RECEIPT DATE: 5-2-24 **ONSITE SEWAGE DISPOSAL SYSTEM** P 586602

APPROVAL DATE: 8/6/2024 **PERMIT: BAT New Construction** A \_\_\_\_\_

PROPERTY ADDRESS: 540 Watersville Road

**SITE PLAN FOR BAT INSTALLATION**

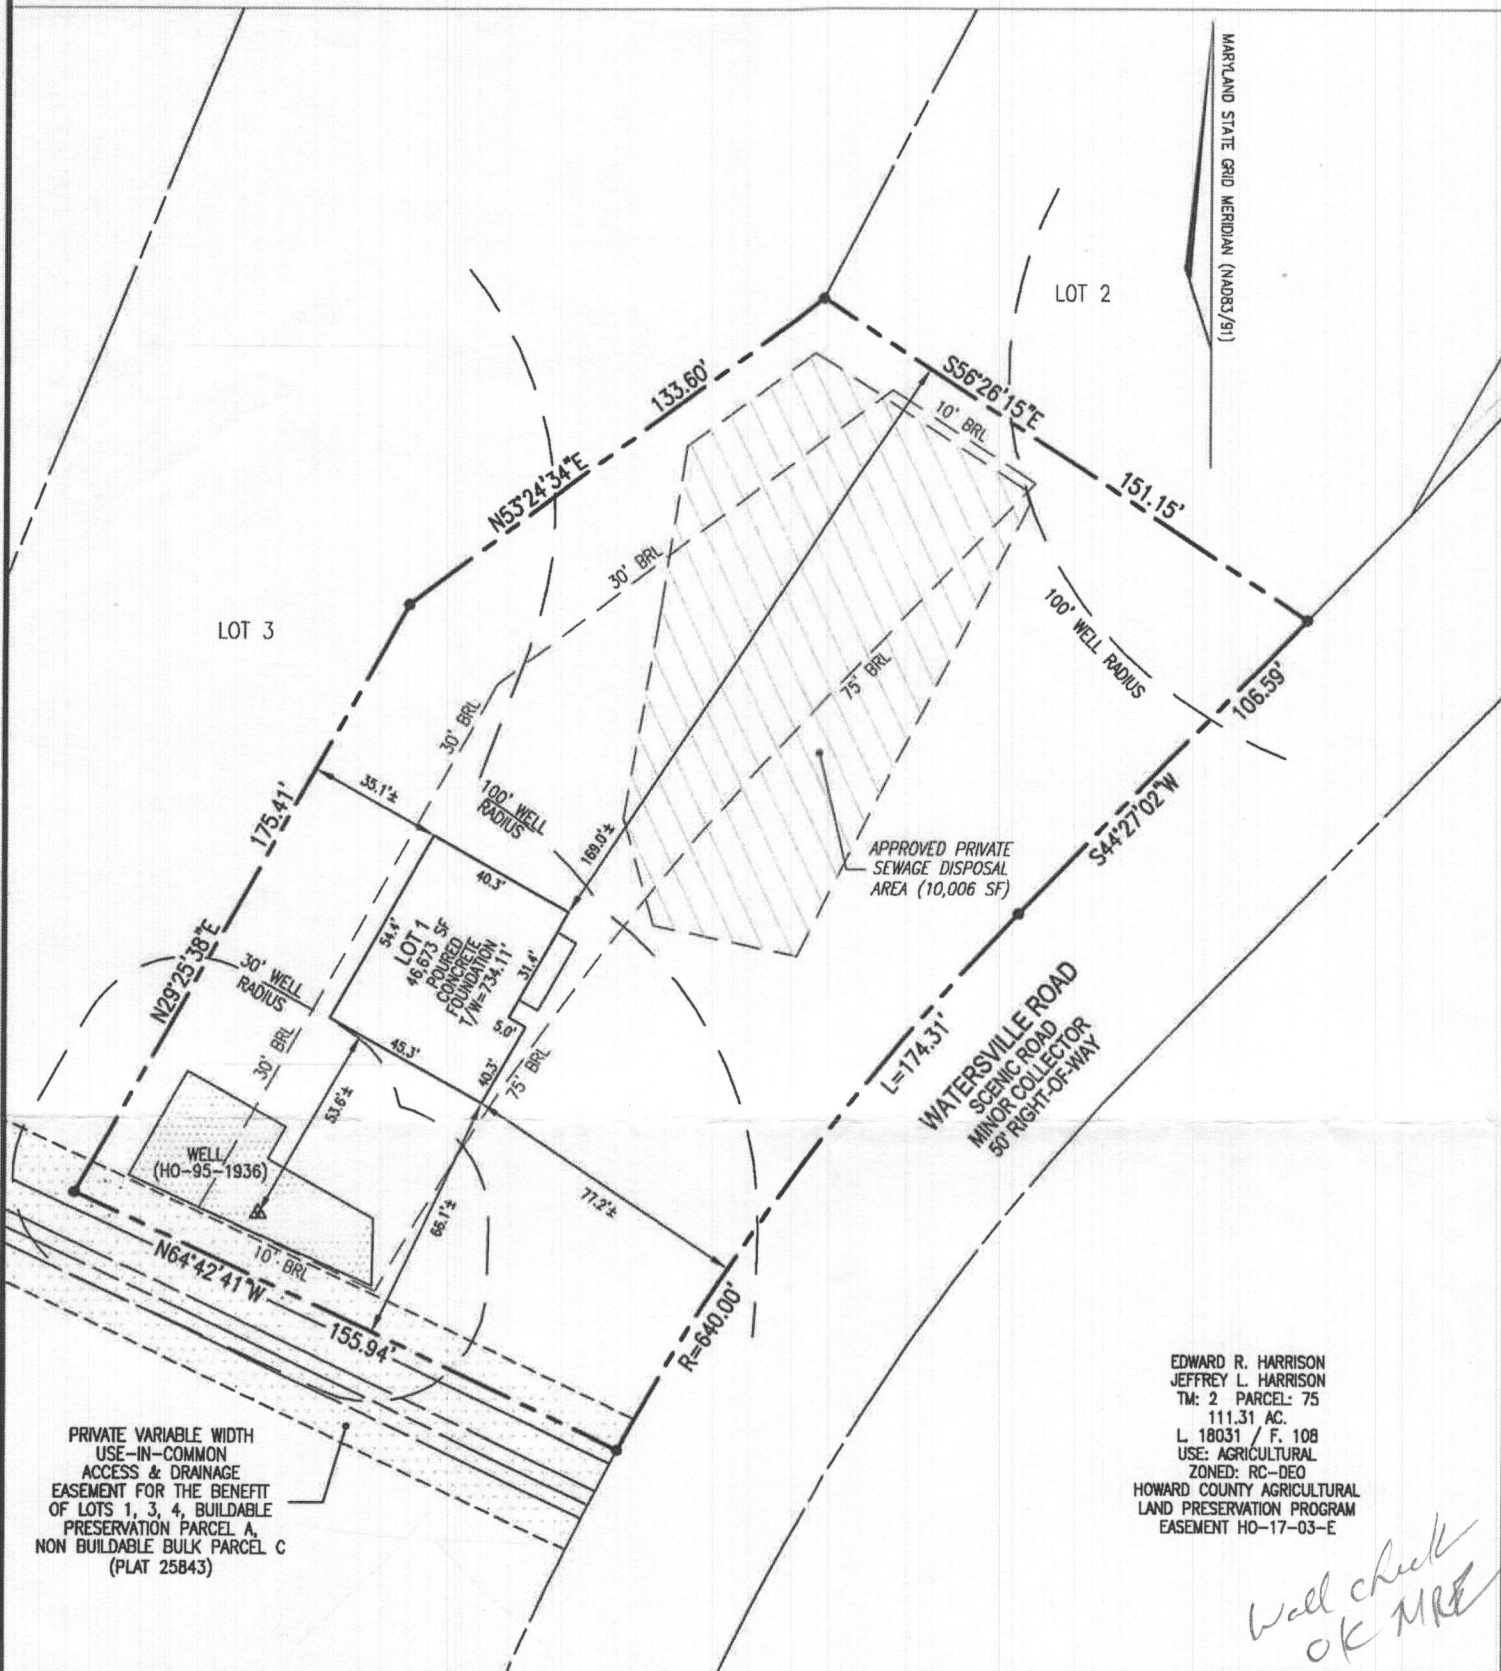
*Wall check  
OK MRE*

**1,000 GALLON PUMP TANK 1-Compartment**  
Stock Item  
Dwg. No. 1000-P No Scale Jan 1, 2000

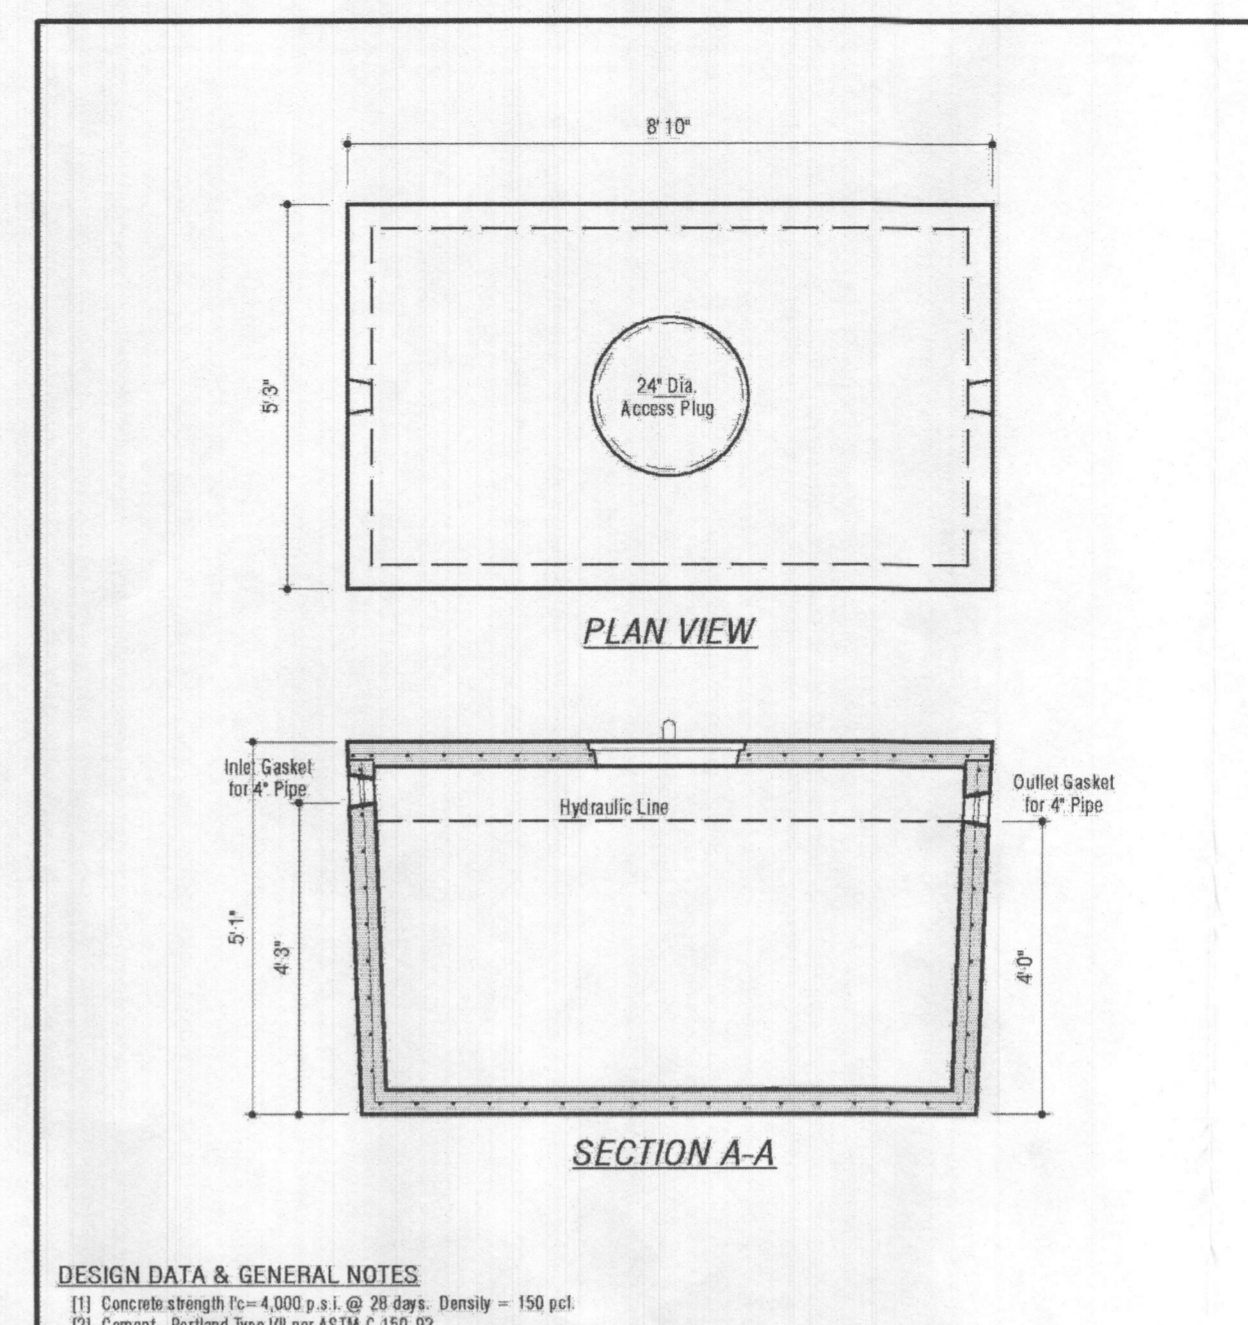
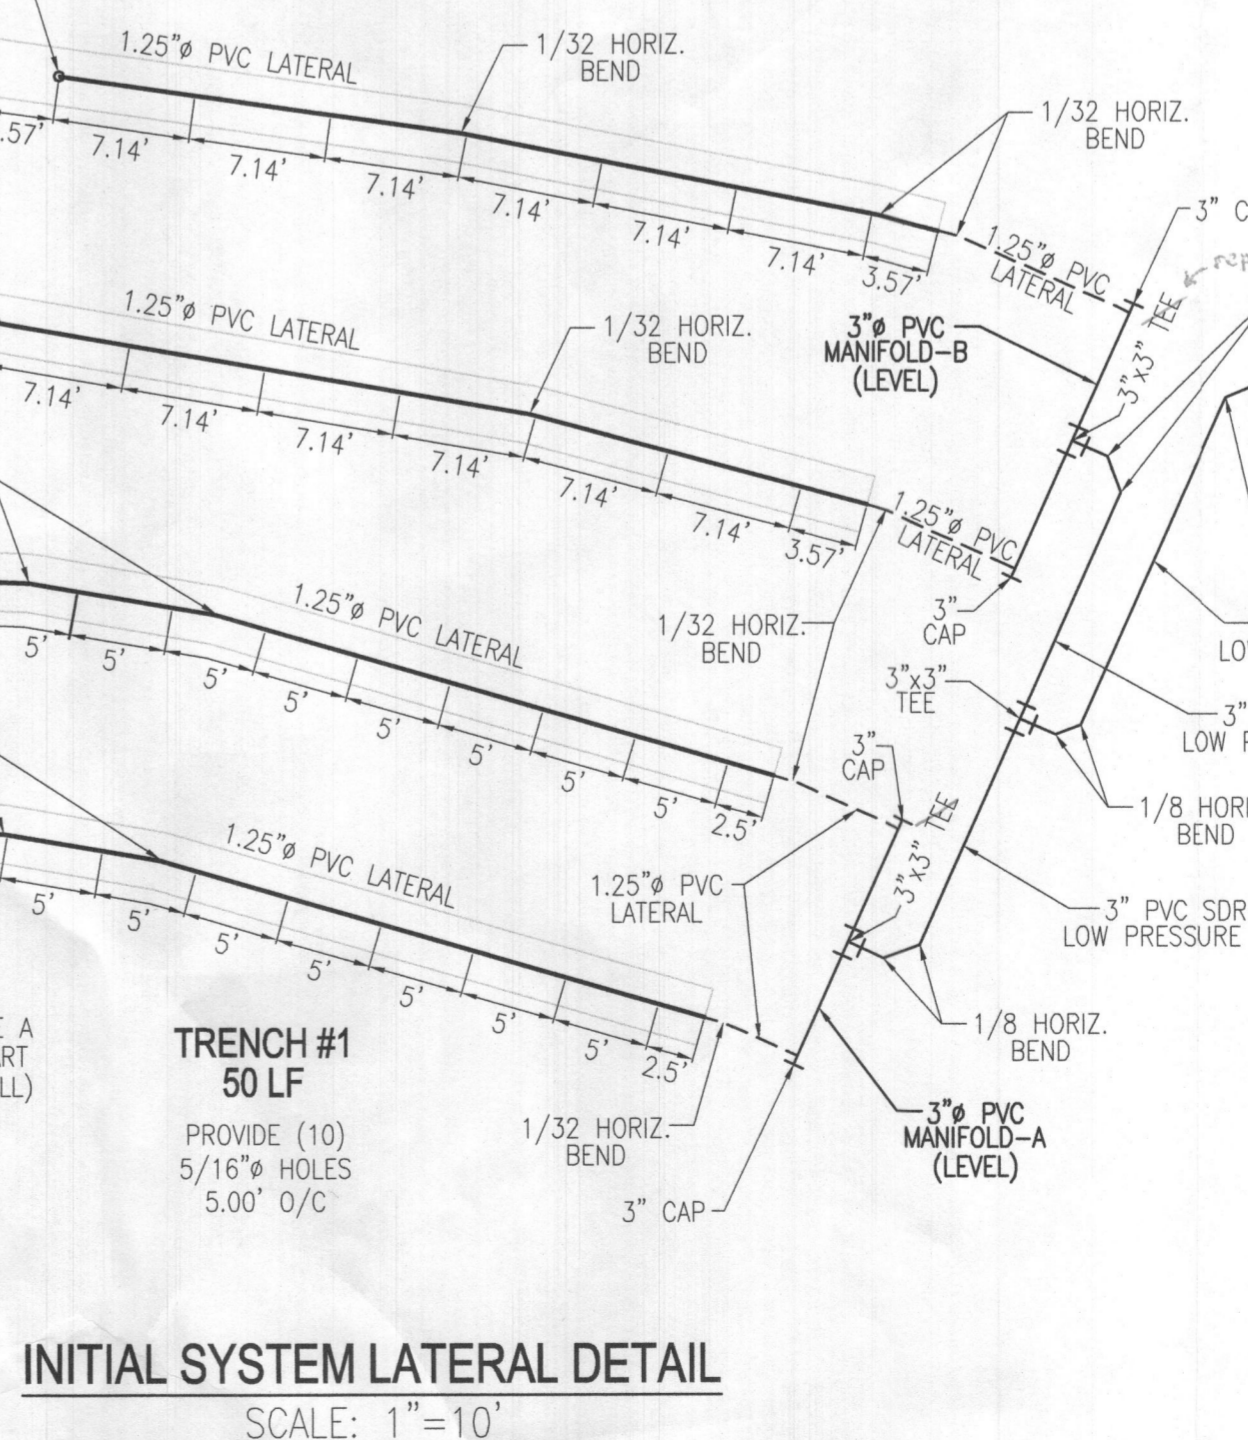
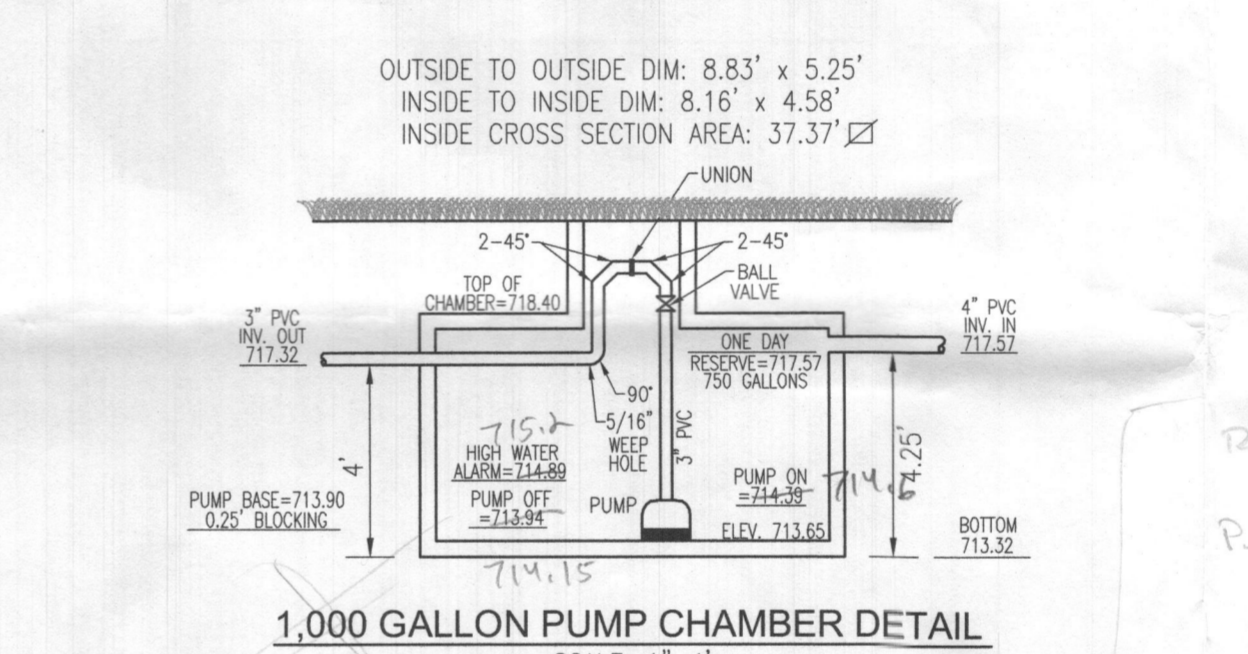
6/11/2024 - Pump tank sized incorrectly, OSDS plan to be revised. SP

- The pump floats are shown in a way that is not possible to install: The pump off float is shown 0.3' from the tank bottom. The lowest a pump off float can be is above the water inlet of the pump and the pump must be resting on a block 6" above the tank bottom. If all the floats are moved up to account for the off float moving up, then there is less than 1 day emergency storage in the pump tank. It appears that the design must show a larger tank to provide a proper location for the off float and then have room for emergency storage on the top end.
- The low pressure design shows 60 gallons per minute flow rate to pressurize the system, but the pump chart plots 30 gallons per minute. This change may still allow for a we03m pump as the head will likely change with the float adjustments. The revised plan must show the new pump curve and appropriate pump selection.

A revised plan must be submitted to our office and we will review it as quickly as possible to get the installer back on track to install the system. Please let me know if there are any questions. Thanks
